RECORD PLANS	
CONTRACTOR:	RENAUD BROTHERS, INC. – VERNON, VT
RESIDENT ENGINEER:	DARYL BASSETT
CONSTRUCTION BEGAN:	DECEMBER 13, 2010
CONSTRUCTION COMPLETE:	JUNE 5, 2013
RECORD PLANS BY:	DARYL BASSETT, NICK GARBACIK & P. BANNERMAN

STATE OF VERMONT
AGENCY OF TRANSPORTATION

PROPOSED IMPROVEMENT
BRIDGE PROJECT
TOWN OF HARTFORD (WILDER)
COUNTY OF WINDSOR

ROUTE NO : TH 29, CLASS 3 (LOCAL) BRIDGE NO : 38

ABUTMENT 1 PLAN VIEW

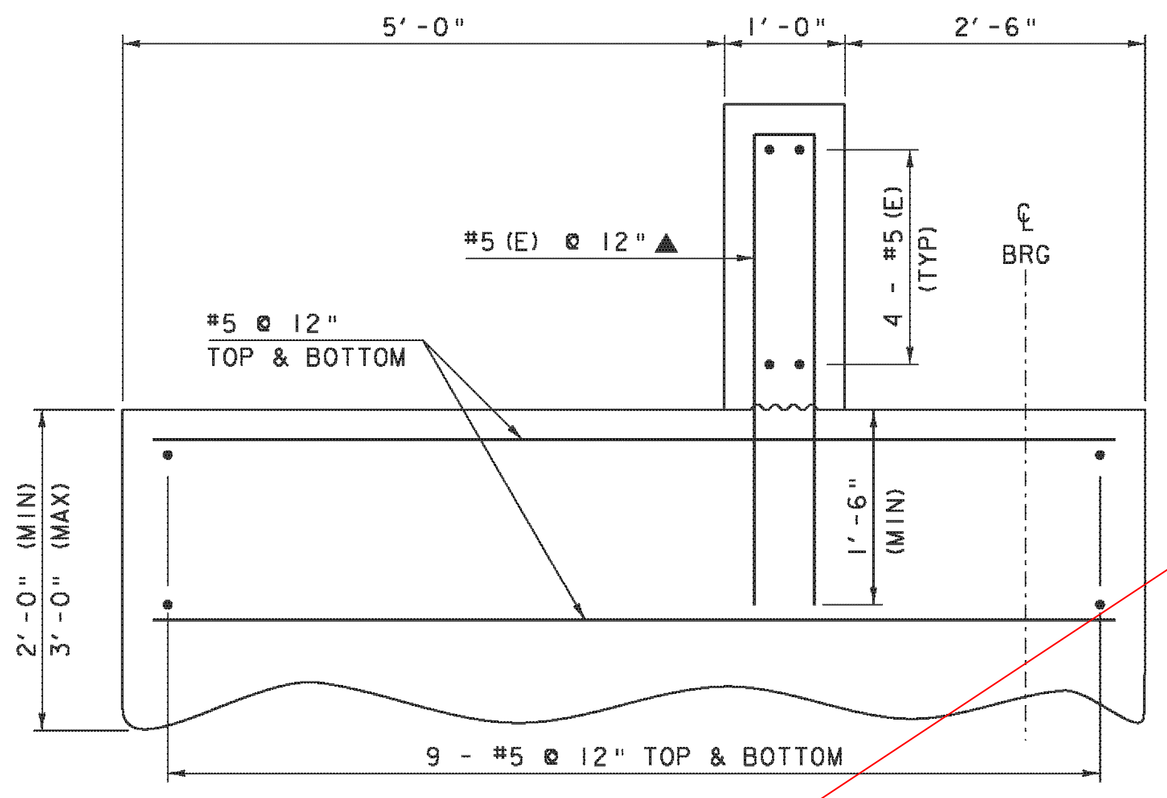
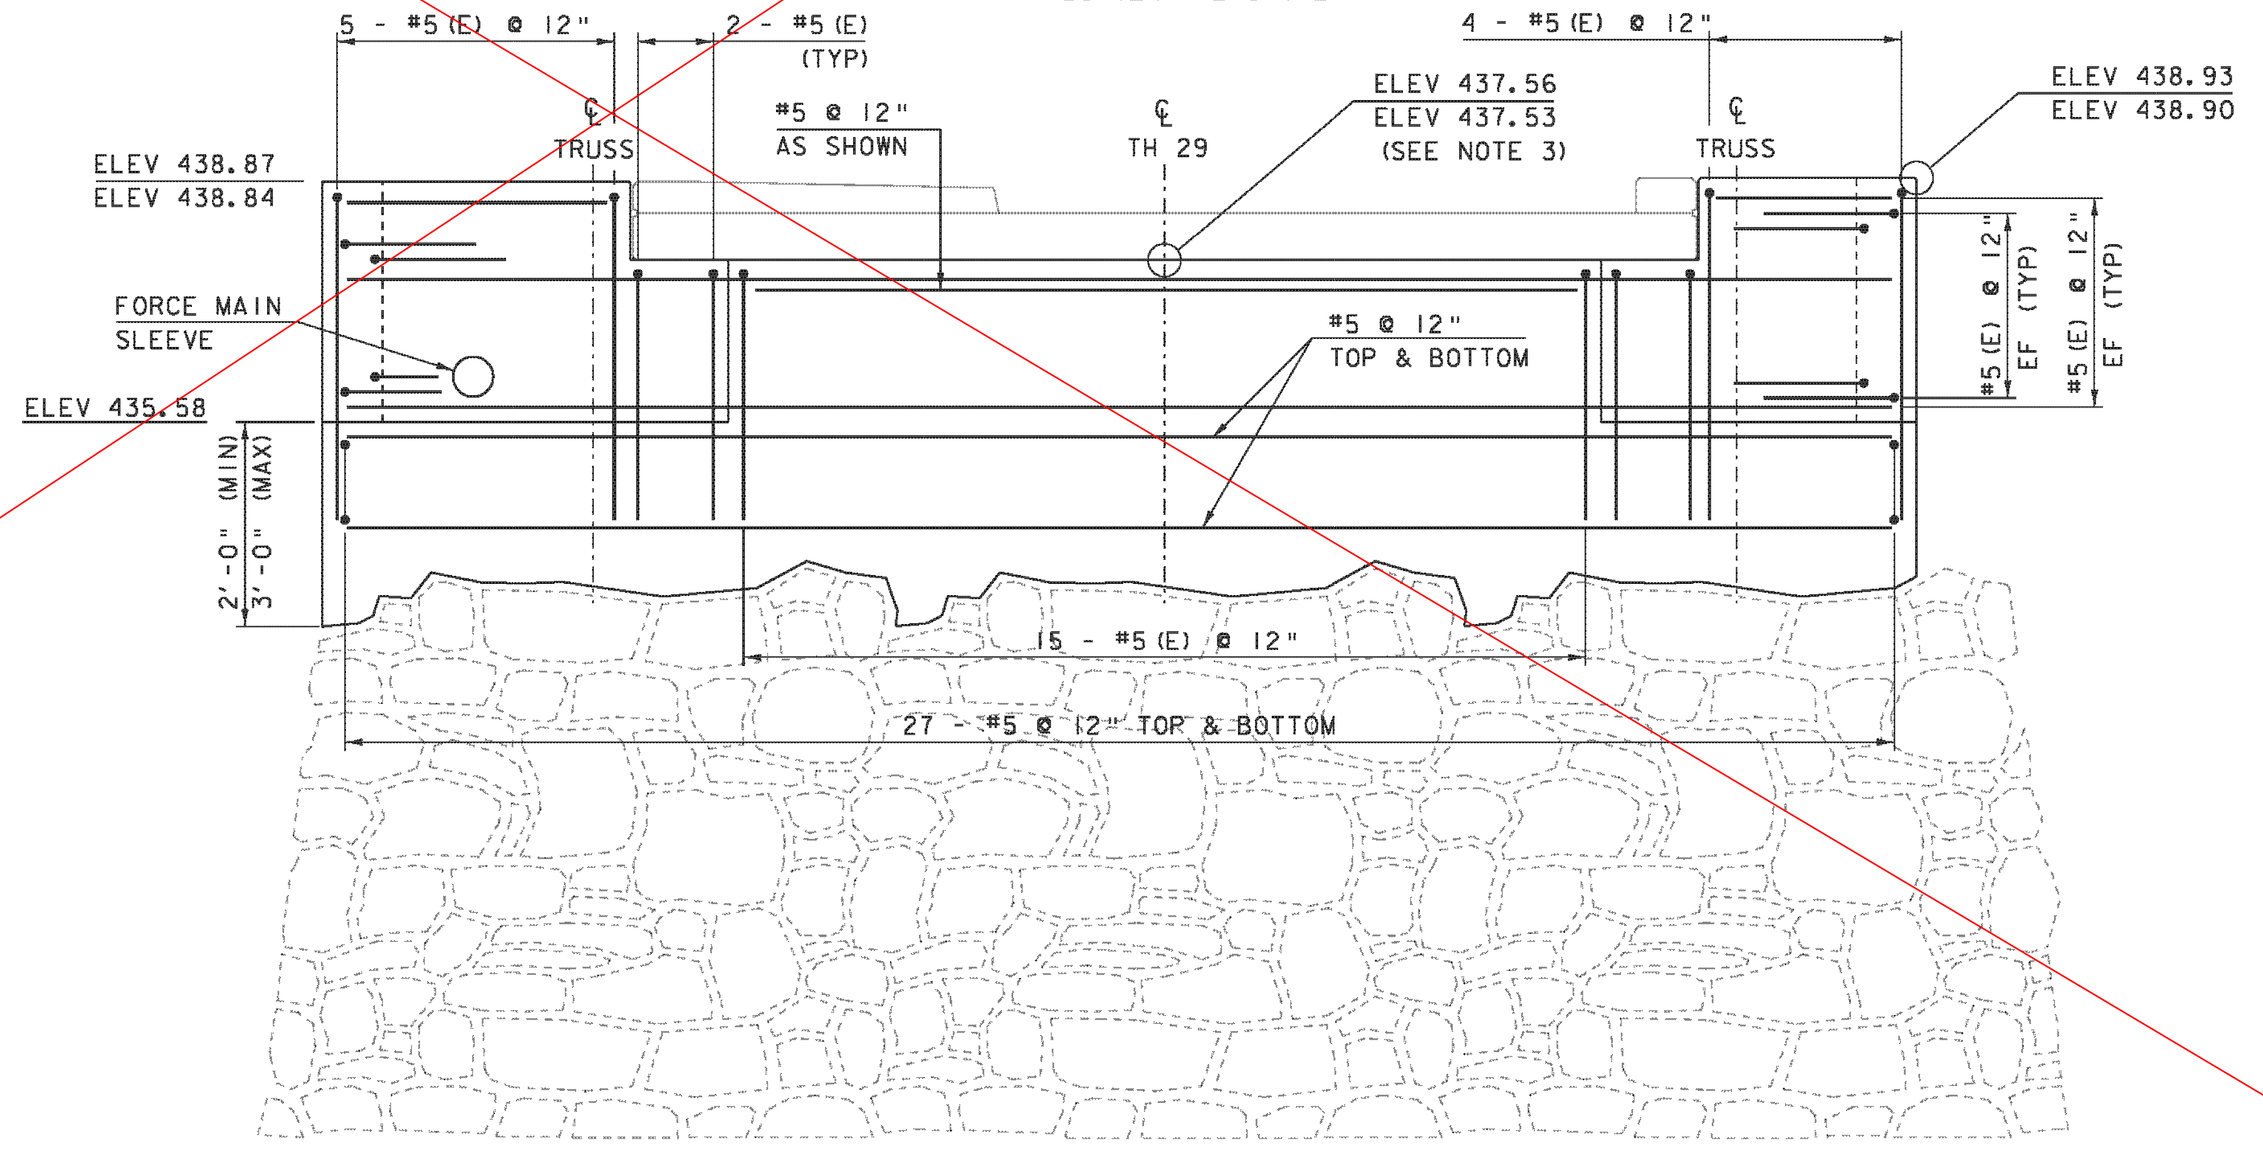
SEE REVISED ABUTMENT DRAWINGS SHEET 1OF 1 DATED 4/25/12

PLAN

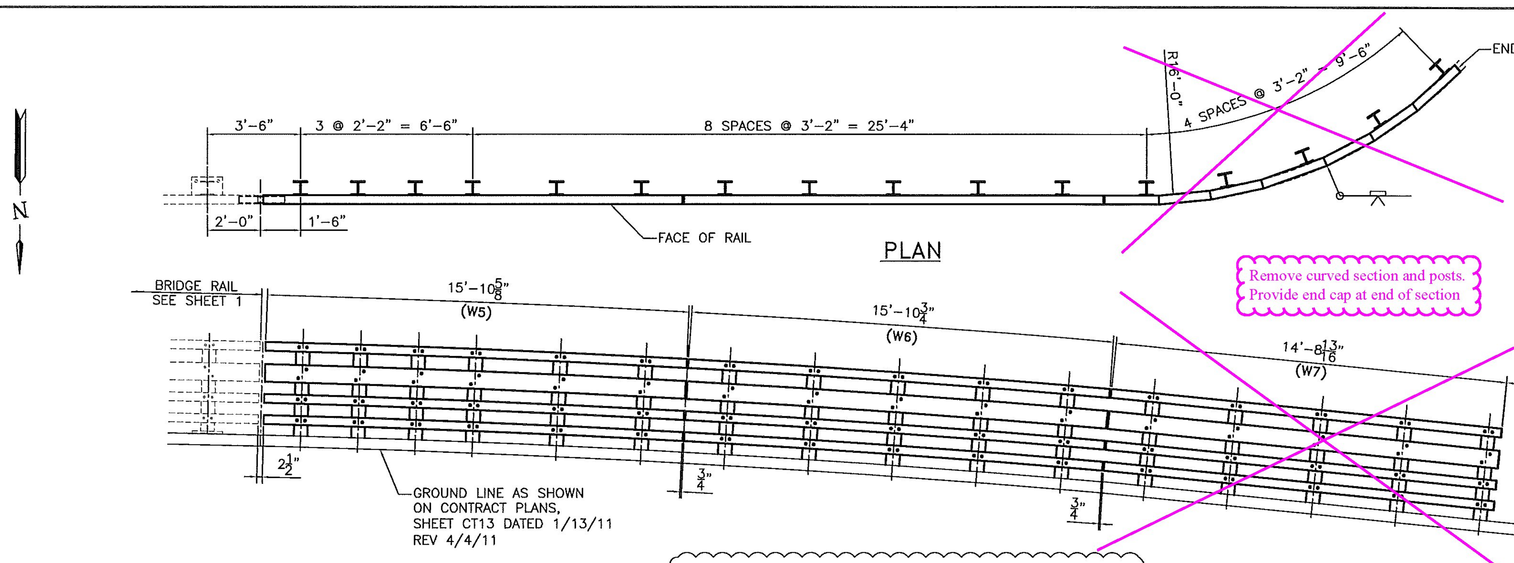
Remove curved section and posts.
Provide end cap at end of section

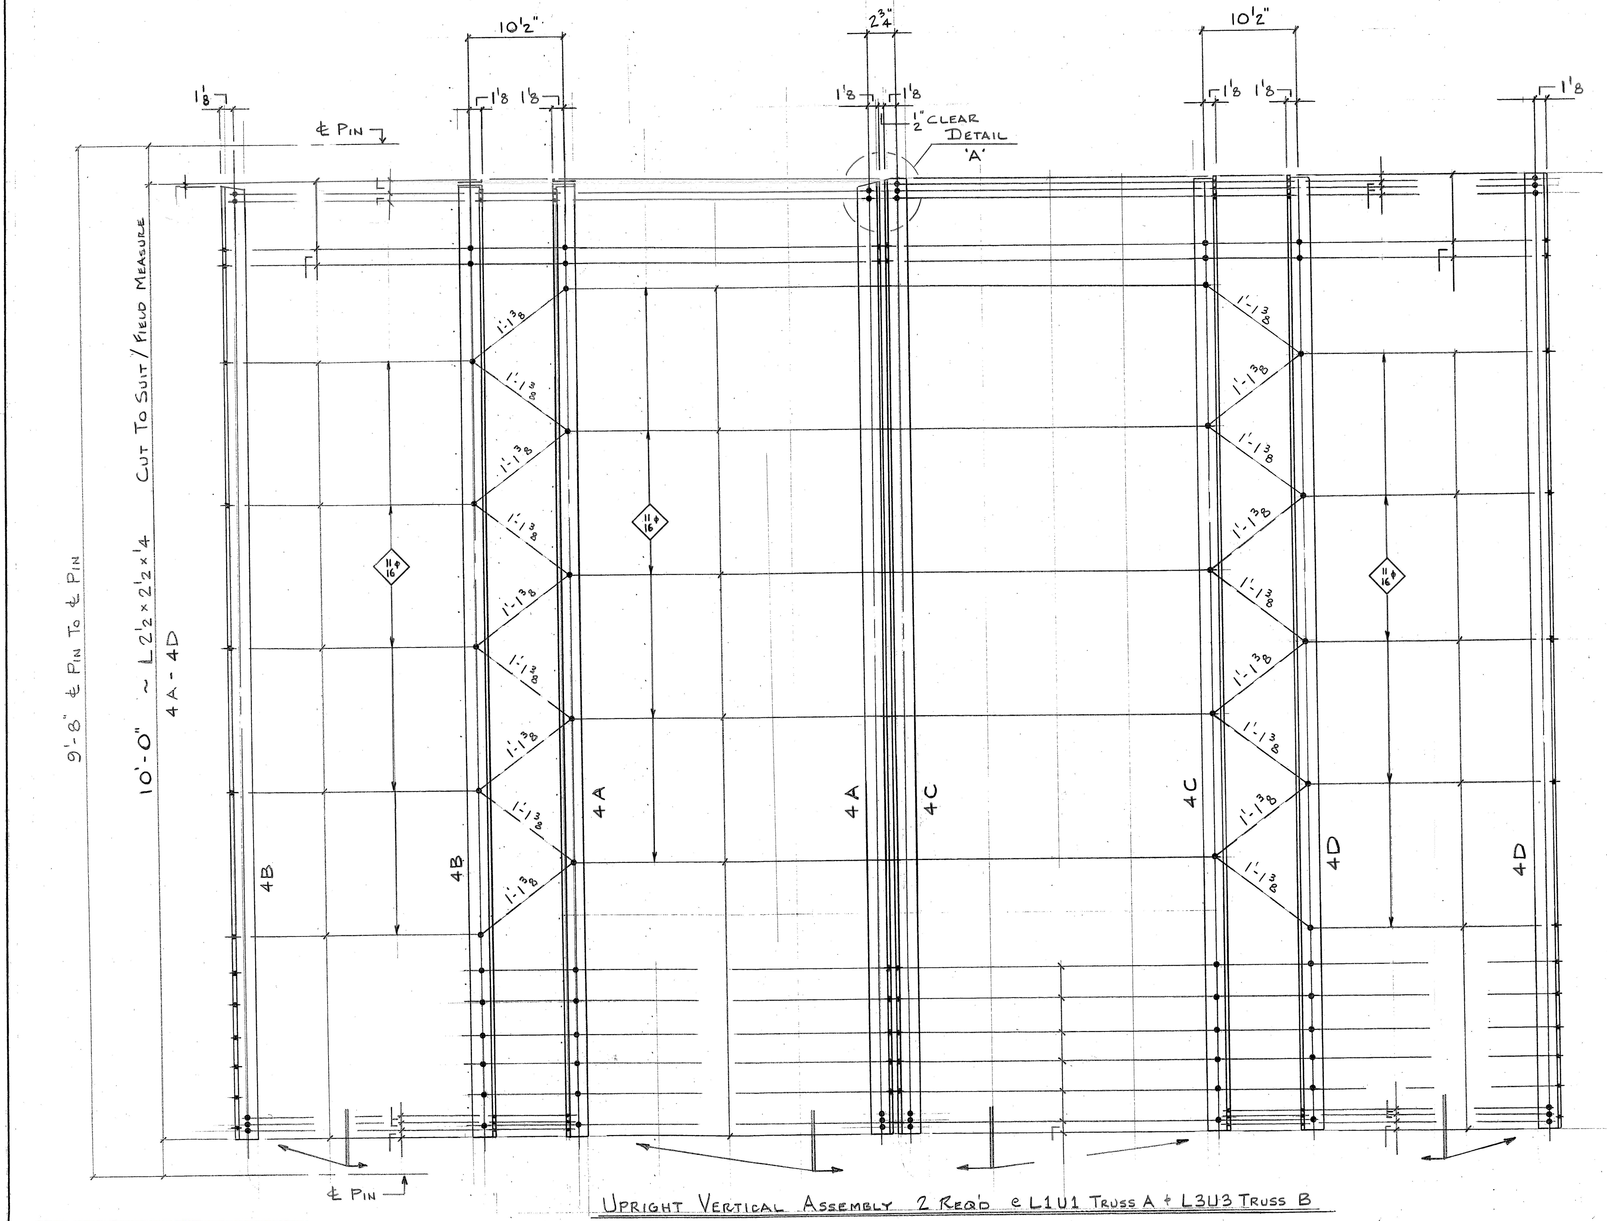
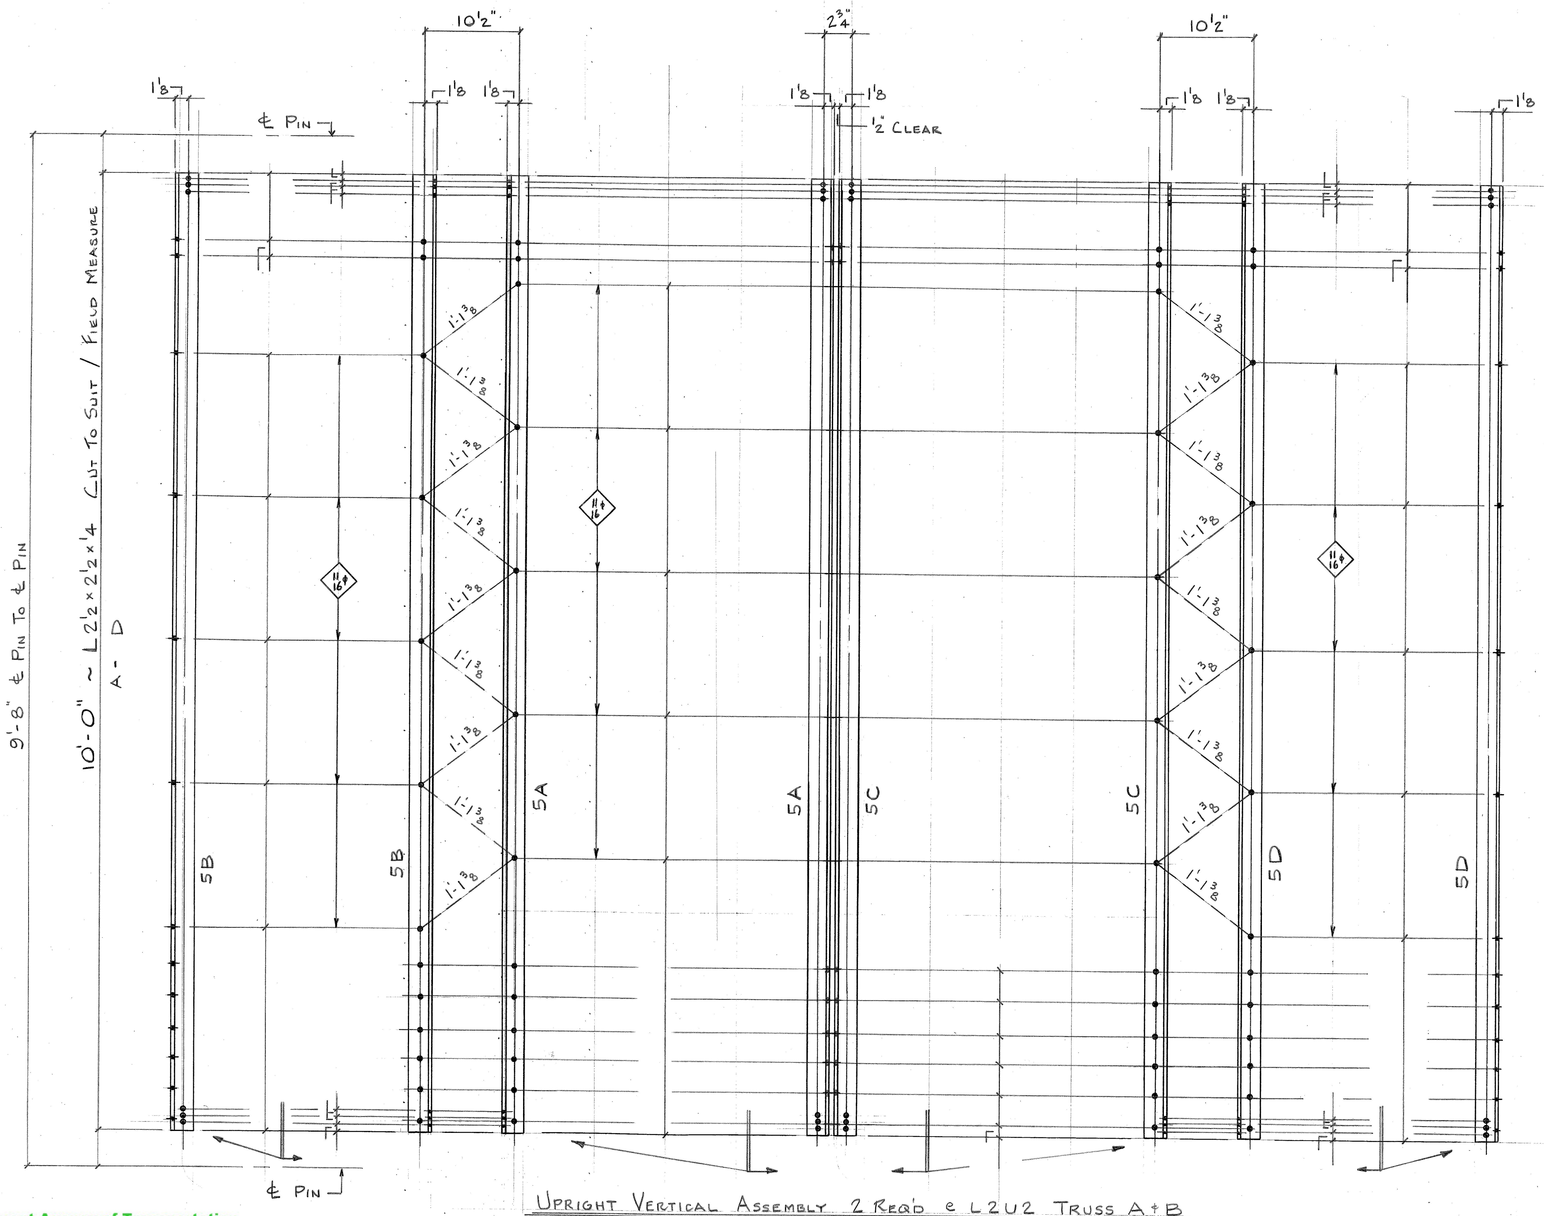
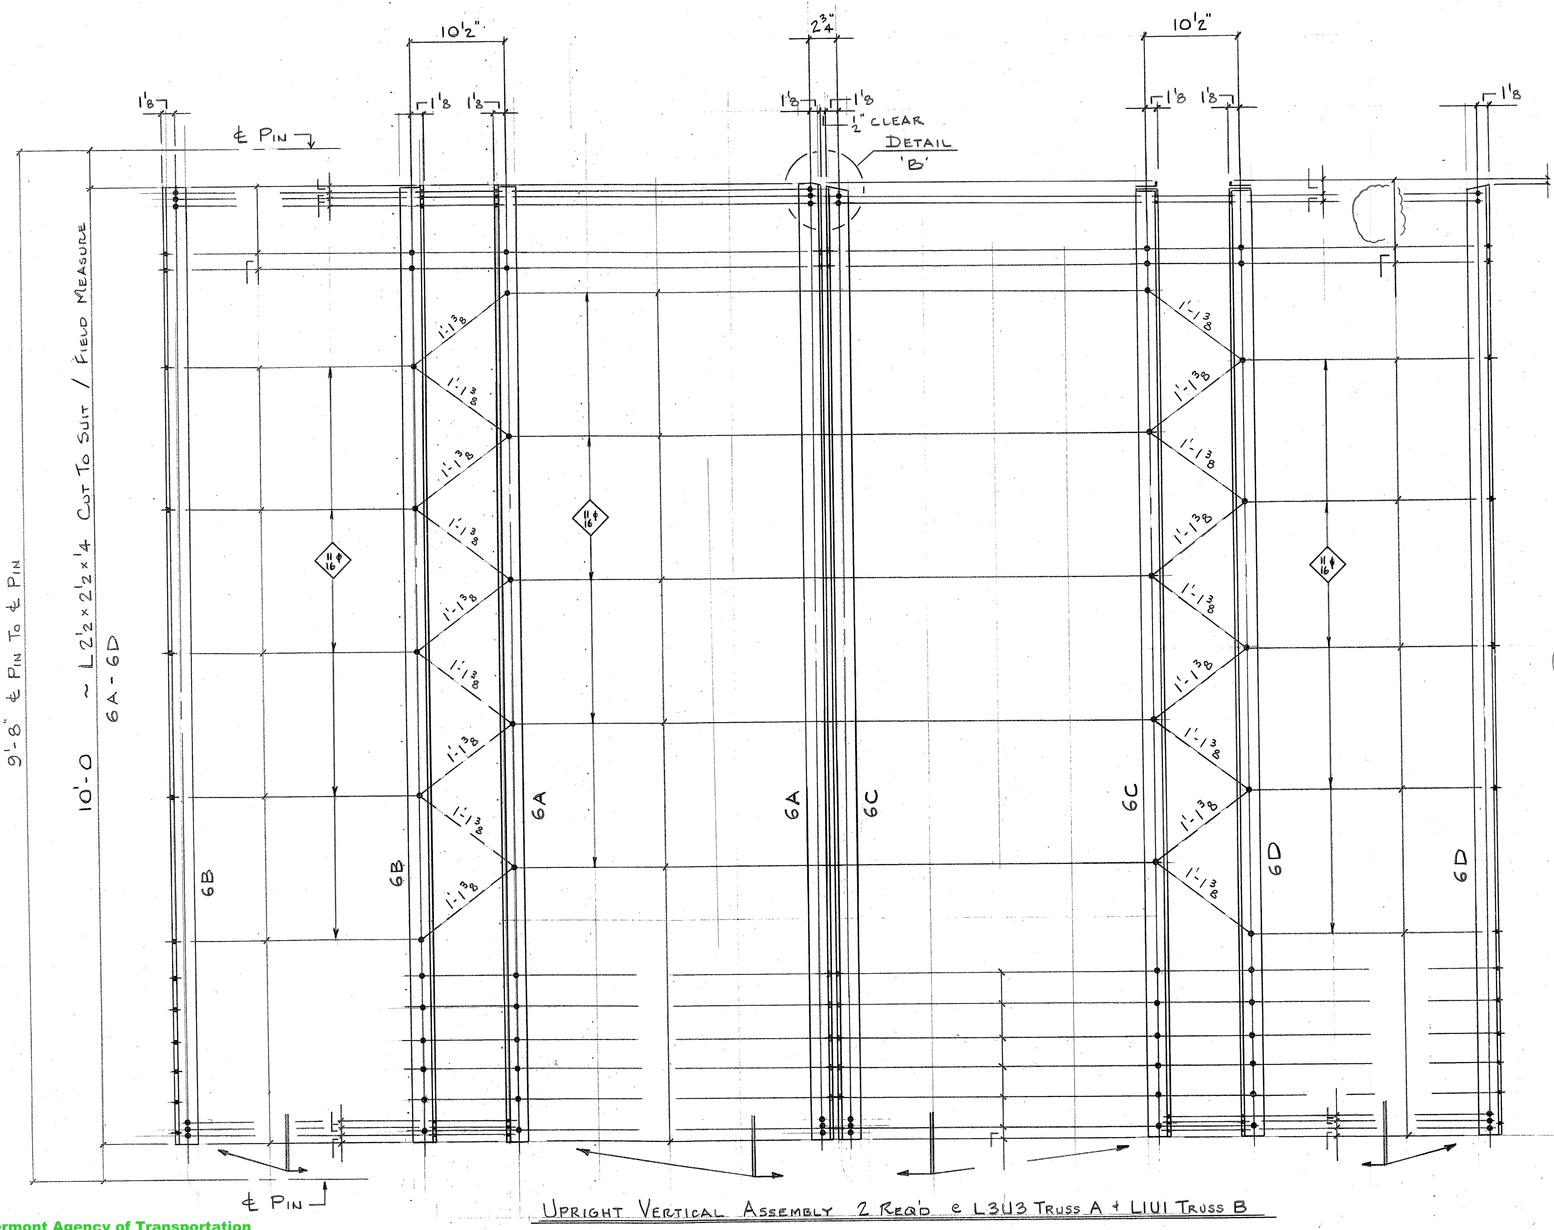
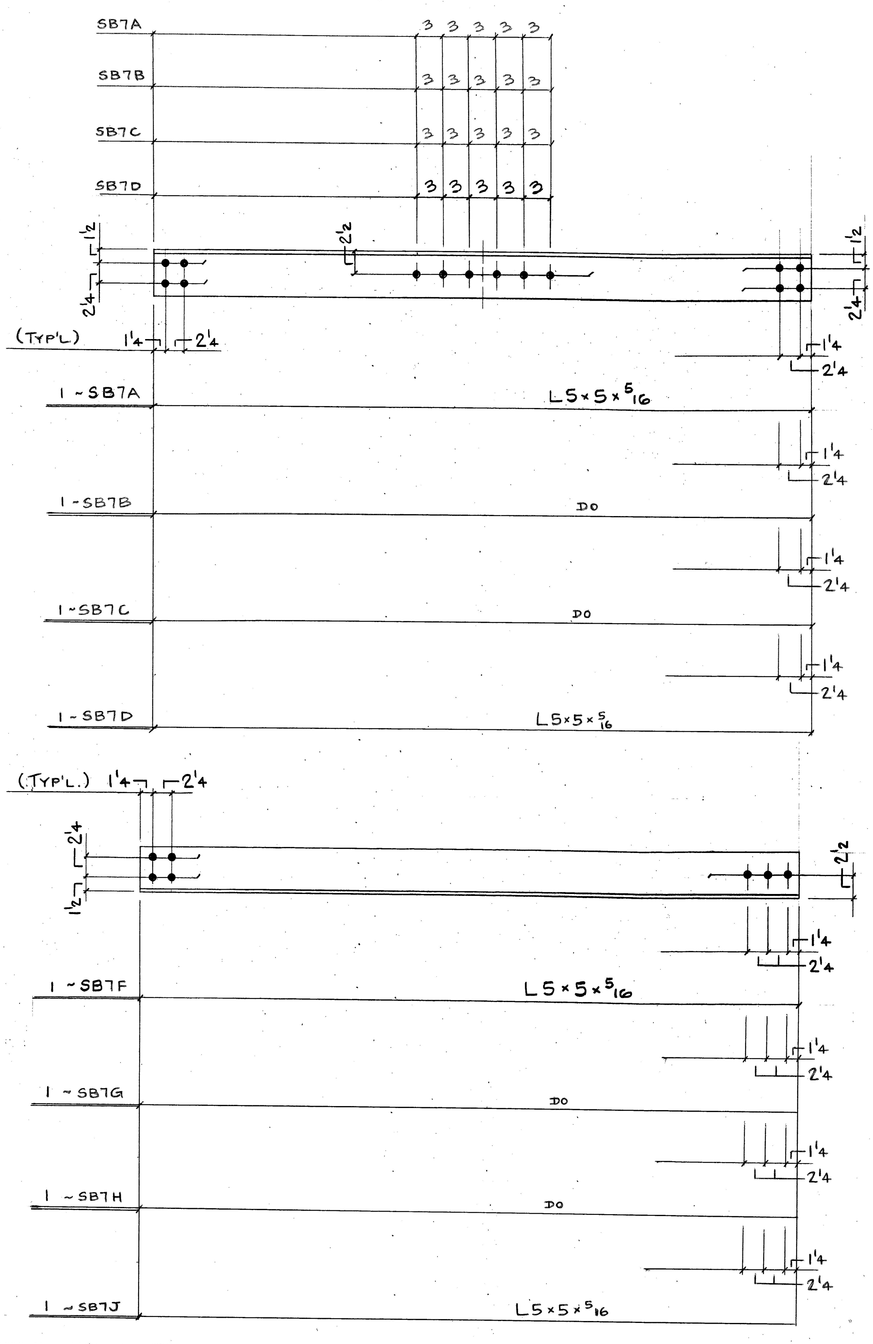
The replacement of members EP1, U1-U2, U2-U1', and EP1' necessitates different details than shown on this sheet. See Sheets 10-13 (1/4-4/4) for modifications.

The replacement of members EP1, U1-U2, U2-U1', and EP1' necessitates different details than shown on this sheet. See Sheets 10-13 (1/4-4/4) for modifications.

The replacement of members EP1, U1-U2, U2-U1', and EP1' necessitates different details than shown on this sheet. See Sheets 10-13 (1/4-4/4) for modifications.

The replacement of members EP1, U1-U2, U2-U1', and EP1' necessitates different details than shown on this sheet. See Sheets 10-13 (1/4-4/4) for modifications.
